## PRODUCT CHANGE NOTIFICATION

#PCN-TT-G68O-14

Business Unit	Product Line Code	Type of Change	Action	Date of issue
TT	CL3	Electrical	Notify Distributors and Field	5/28/2014

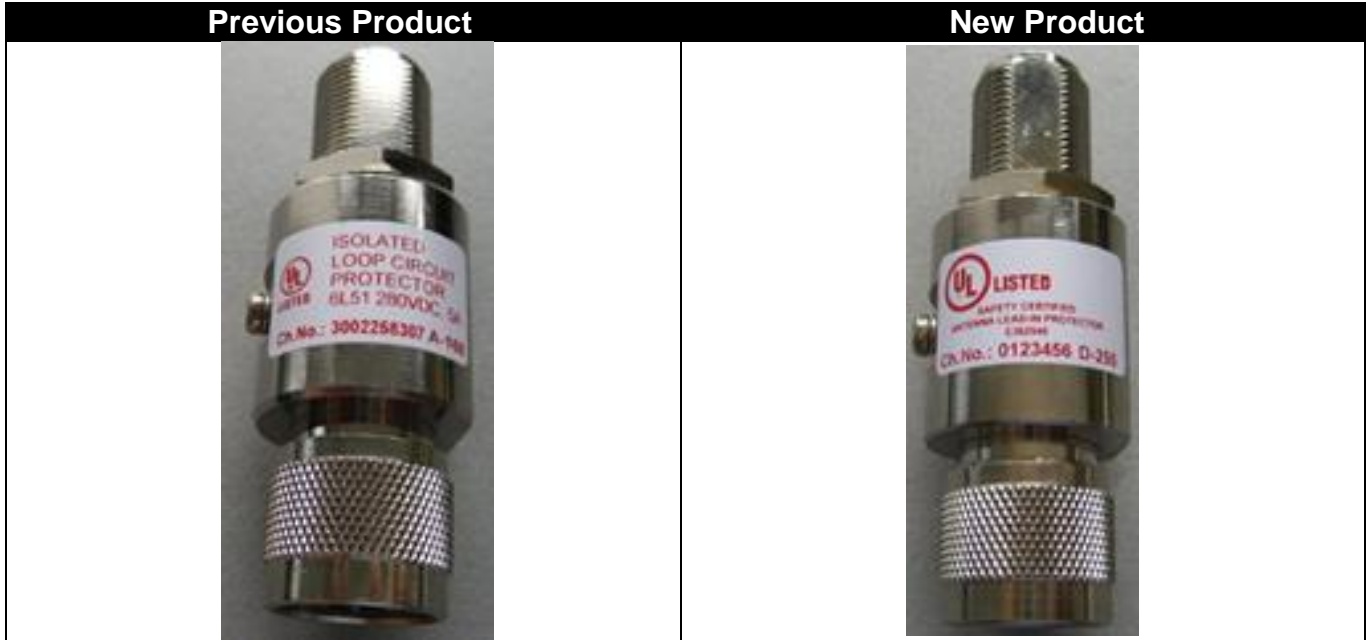
The UL approval has been changed on the label. No electrical or mechanical changes have been made to the indicated product(s).
